8. COA-048388-2019

2711 East Broad Street

Commission of
Architectural Review

Construct a two-story secondary building.

Figure 1. Sanborn Map 1905

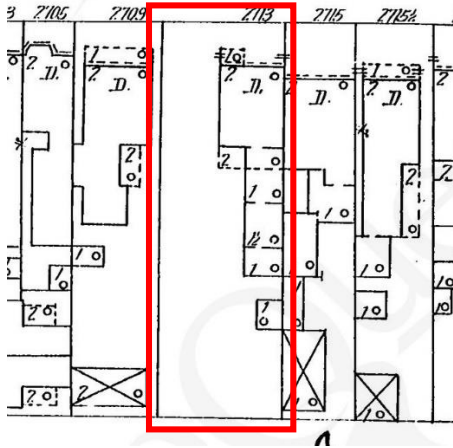
New Construction, Residential Outbuildings, pg. 51, #s1-3	<p>1. <i>Outbuildings, including garages, sheds, gazebos and other auxiliary structures, should be compatible with the design of the primary building on the site, including roof slope and materials selection.</i></p>	The applicant has revised the plans and now proposes to utilize a shed roof which mirrors the roof of the house.
	<p>2. <i>Newly constructed outbuildings such as detached garages or tool sheds should respect the siting, massing, roof profiles, materials and colors of existing outbuildings in the neighborhood.</i></p>	The proposed secondary building is located at the rear of property. It utilizes a roof form and materials found on other secondary resources in the district.
	<p>3. <i>New outbuildings should be smaller than the main residence and be located to the rear and/or side of the property to emphasize that they are secondary structures.</i></p>	While the mass of the proposed secondary building is smaller than the primary resource, staff is concerned that it appears to be similar in height. Sanborn maps indicate the presence of a one-story outbuilding on the site, and <u>staff recommends that the height of the building be reduced.</u> Staff also notes that either end of the alley historically had two-story secondary buildings, though the interior of the block did not.
